# SERVICE BULLETIN

SB1343

**SUBJECT** : Introduction of improved sealing between upper

windshield and trim panel

Figure 1: Seal between upper windshield and trim panel

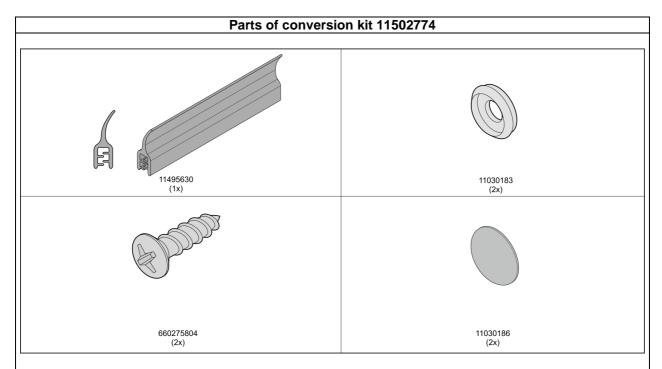
To avoid objects dropping between the upper windshield and the trim panel, a larger neoprene seal has been installed on production coaches. This seal can be installed on older coaches as outlined below.

Figure 12

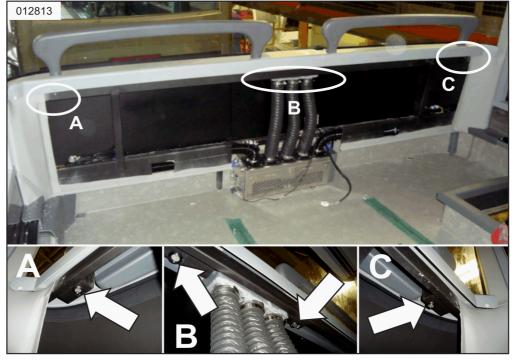
Only in case that grab handles are present: Fit the handles to the trim panel by 2.5 using the original screws.
